STAIR NOSING DETAIL, THE SEVEN STARS

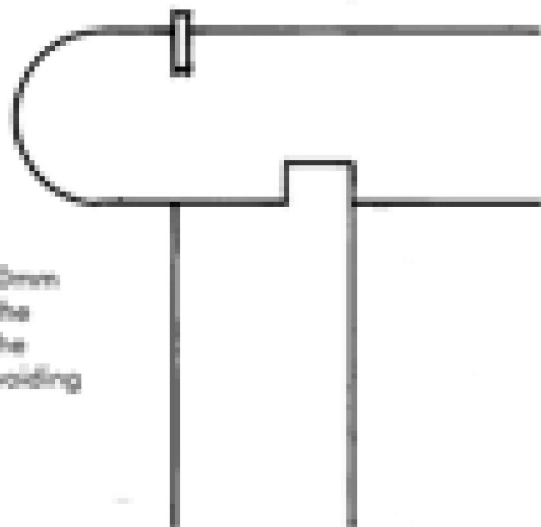
NO

The riser rebate and the stainless steel insert are both cut 30mm from the nose of the tread, possibly leading to a crack across the width of the tread.

YES

The stainless steel insert is cut 30mm from the nose of the tread, but the rebate is made for the back of the riser instead of the front, thus avoiding a double reduction of the tread thickness in the same place.
